## ALPINE CITY PLANNING COMMISSION MEETING

- A. **David's Court Preliminary Plan - Approx. 355 East Healey Blvd. - Patterson Construction Inc.**  
The Planning Commission will review the preliminary plan for the proposed David's Court subdivision.

By: Jed Muhlestein, P.E. *JM*  
Assistant City Engineer

**Subject: David's Court Subdivision – Preliminary Review**  
**15 lots on 16.42 acres**

| SHEET NAME | SHEET NUMBER |
|------------|--------------|
| UTILITY    | C2           |

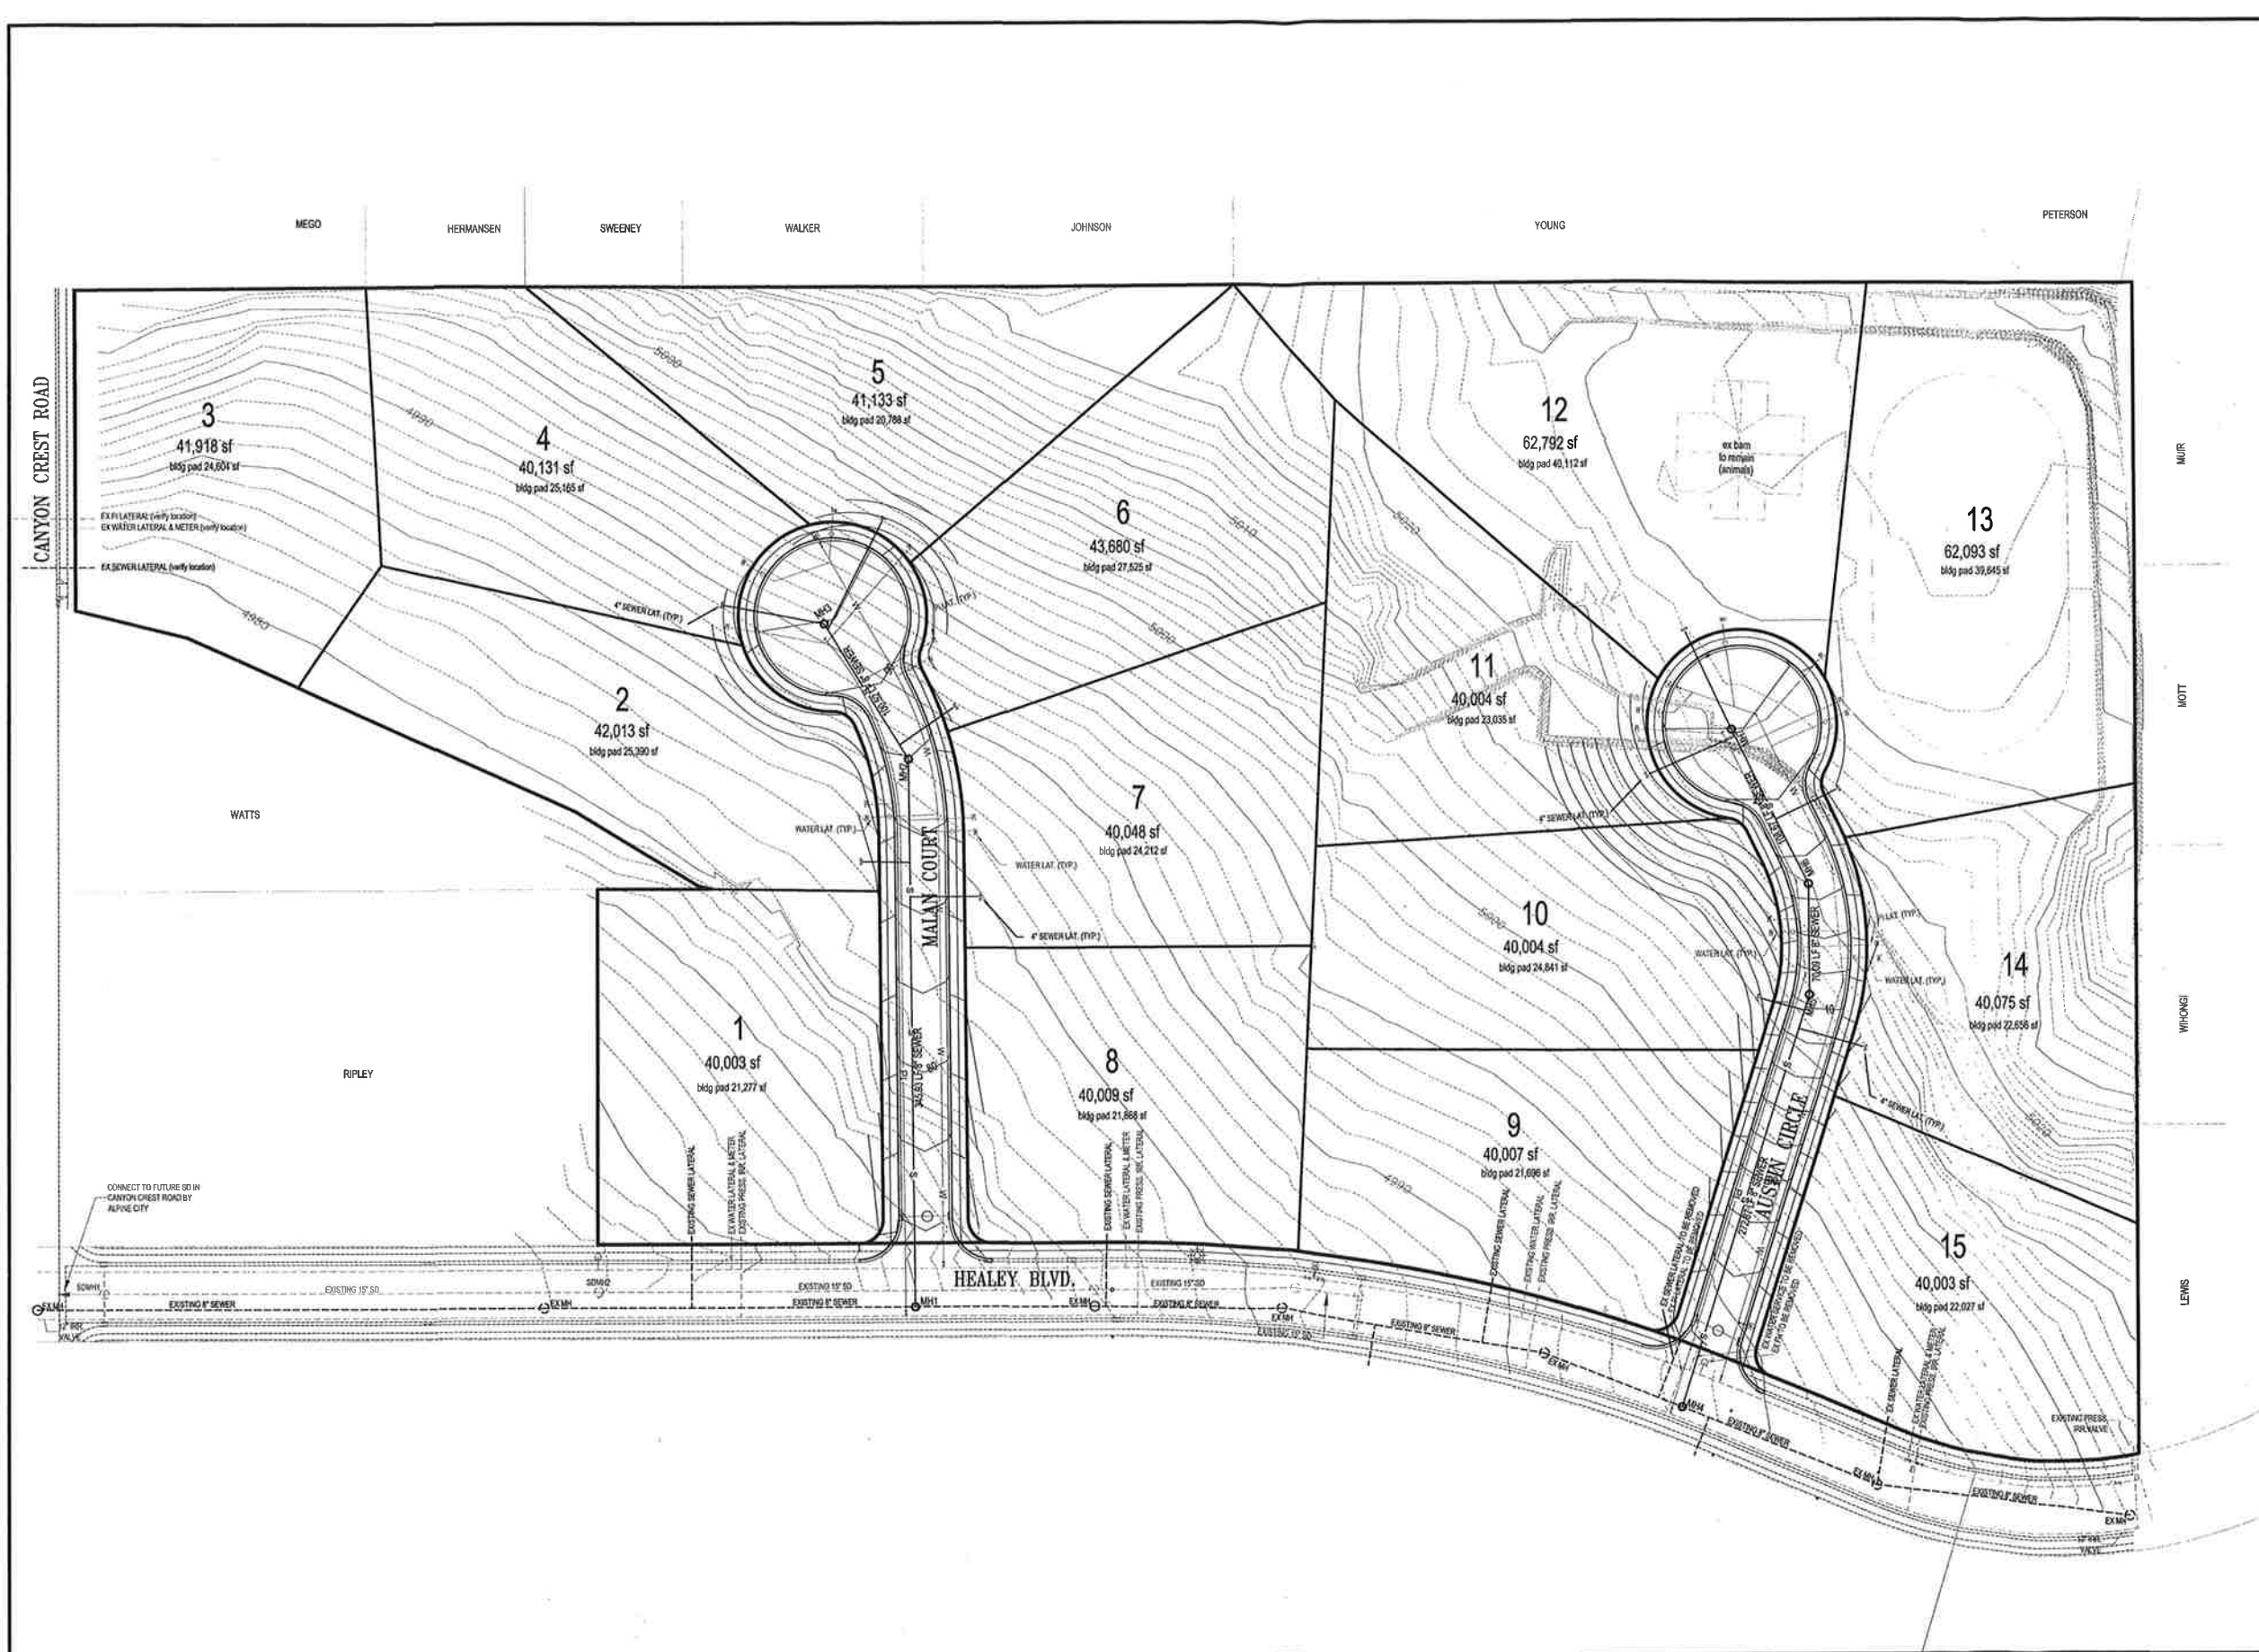
The subdivision is well below the 5350 foot elevation, which is the highest elevation the existing water system can serve and still provide a minimum 40 psi required by ordinance. There is currently an 8-inch water line running in Healey Boulevard that can serve the development. Additionally, there are five water meters already set on the northern right of way of Healey Boulevard. Four are shown to be utilized. One will be removed as it does not fit in with the site plan.

The standard home in most water model systems is considered to be 3,600 square feet with a demand of 1,000 gpm for fire flow. Not very many homes in the CR-40,000 zone of Alpine are 3,600 square feet or smaller. Therefore, Alpine's culinary water model system is evaluated based on providing a minimum level of service for a home of 4,800 square feet which demands 1,750 gpm for fire flow. In order to meet this level of service an 8-inch line in the westerly cul-de-sac and a 10-inch line in the easterly cul-de-sac would be required. If homes are built bigger than this, even larger lines or fire sprinklers would be required.

The issue of homes larger than 4,800 square feet needs to be discussed with the developer with the involvement of the Fire Chief. One possible solution could be to require fire sprinklers in any home larger than 4,800 square feet. A note recorded on the plat could achieve this. Another solution could be to restrict the size of homes to something large, say 10,000 or 15,000 square feet, then run the water model and adjust the line sizes accordingly. The water model shows this area being sensitive to fire flow requirements. We need to be careful about what size of lines and what size of homes are put here for that reason. We are open to suggestions from the developer as well.

Other than the issue of size of homes, the culinary water design is provided and approved pending a few minor redline modifications.

From our experience another fire hydrant should probably be added at the intersection of the westerly cul-de-sac but the Fire Chief will need to approve the location of the proposed fire hydrants. 3/4-inch service lines with 3/4-inch water meters will need to be constructed for each new lot where existing services cannot be utilized, including Lot 3 on Canyon Crest.

It is also our understanding that in preparation for the area to be developed the developer installed and stubbed a water main northward off of Healey Boulevard several years ago. This stub is not shown on the plans but if it is not going to be used, it must be abandoned at the main.

| SHEET NAME | SHEET NUMBER |
|------------|--------------|
| SEWER PLAN | C3           |

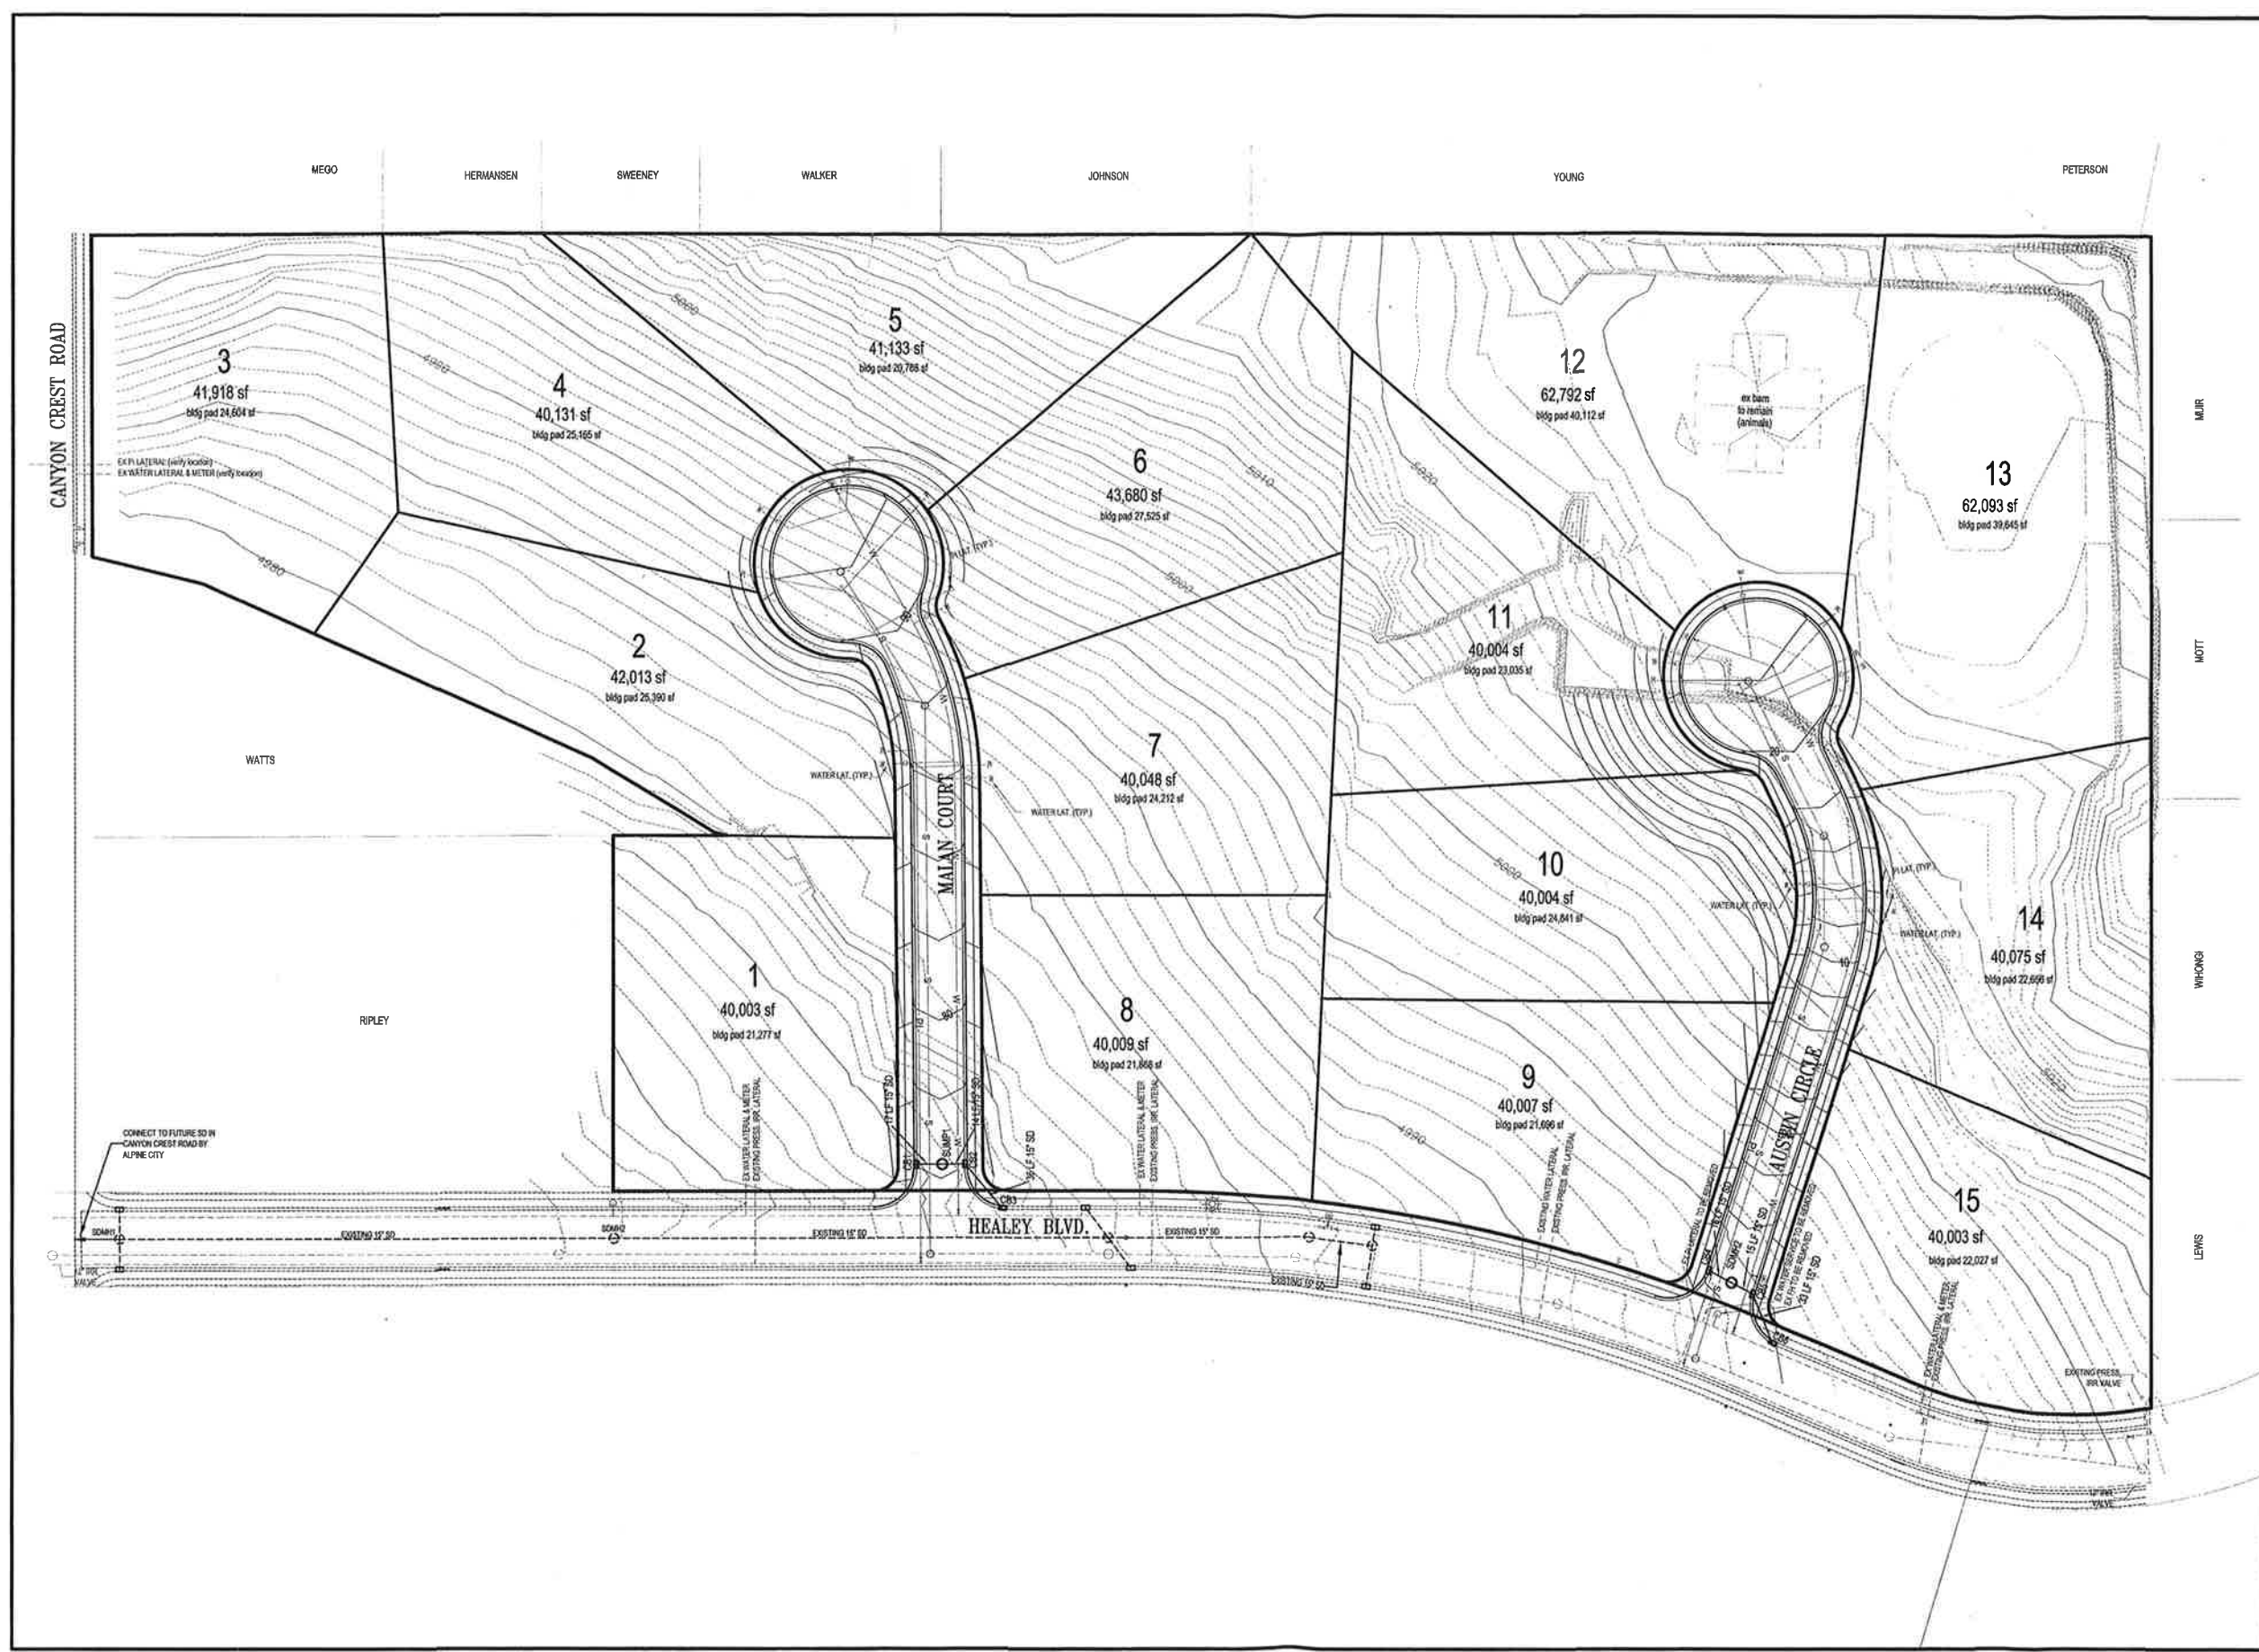
There is an existing 8-inch sewer line running in Healey Boulevard that can serve all but Lot 3 of the development. Some sewer laterals were installed northward off Healey Boulevard in anticipation for the development and most will be used. There is one on Healey Blvd at the

intersection of the proposed cul-de-sac Austin Circle that will be or will remain capped as it is in an un-usable location for the site plan. In order to provide sewer service to Lot 3 an extension of the sewer system in Canyon Crest would need to be built as the nearest sewer manhole to that lot is about 175' to the south. The sewer design is provided and approved. There are a couple redlines that can be worked out prior to final approval.

| SHEET NAME         | SHEET NUMBER |
|--------------------|--------------|
| GRADING & DRAINAGE | C4           |

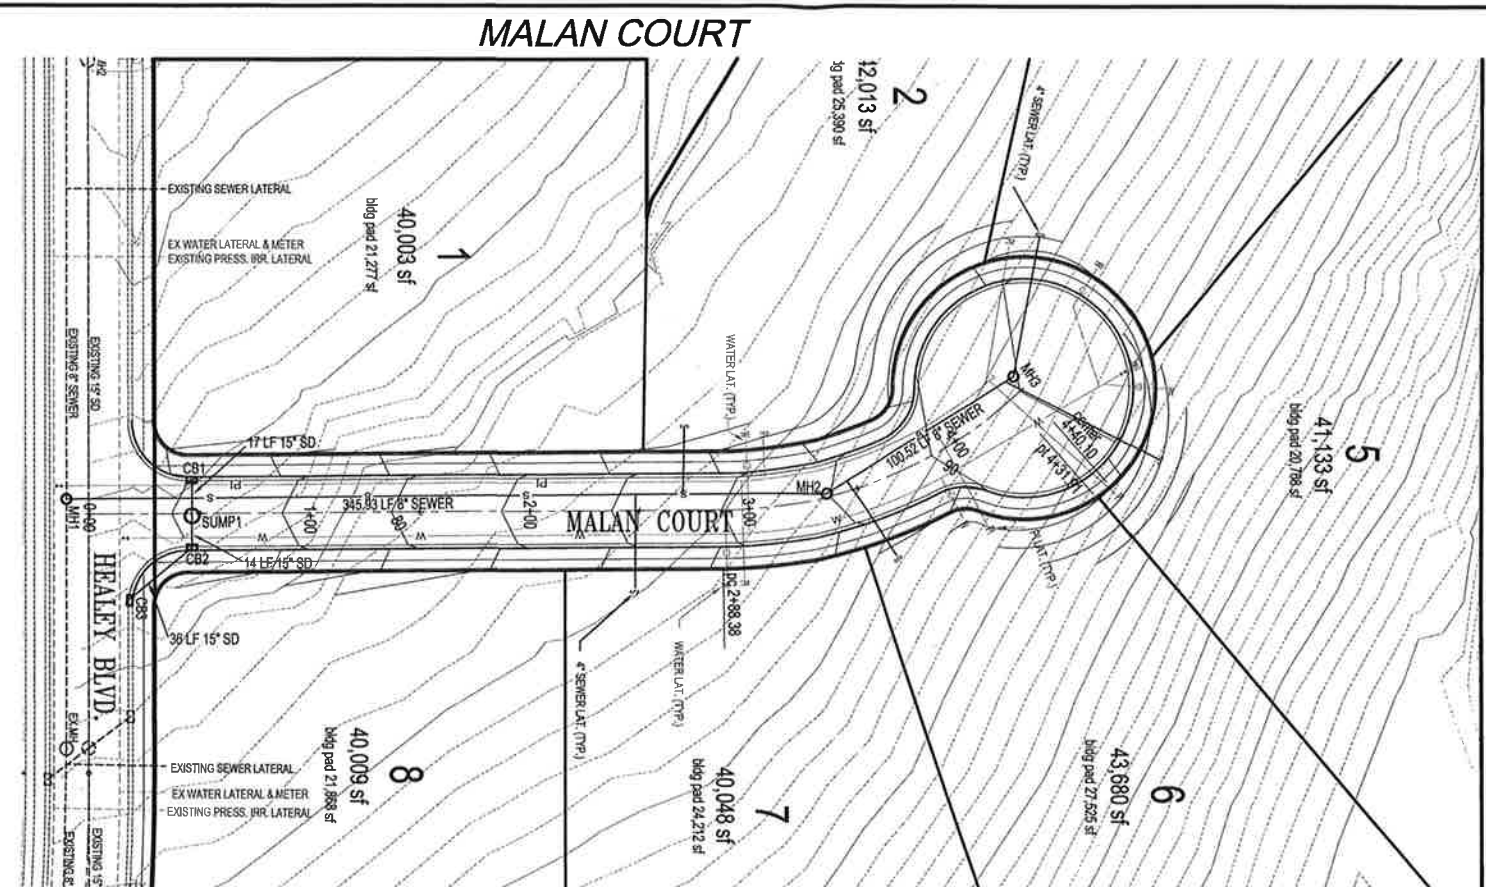
A storm drain design was provided. It shows catchment at the lower end of each cul-de-sac with a sump in the road. Upon further review of the calculations it was found the only the 10-yr storm event was used to calculate the storage volume in the sumps. Section 3.1.1 of the Storm Water Drainage Design Manual states that the 10-year storm event is to be used to "collect and convey storm water" while the 100-year event is used for calculations of major systems. Major systems include retention and detention basins – which is what a sump is. We anticipate a piped system with one or multiple detention/retention basins. It is recommended that storm drain design and calculations be re-submitted prior to Final Review and approval.
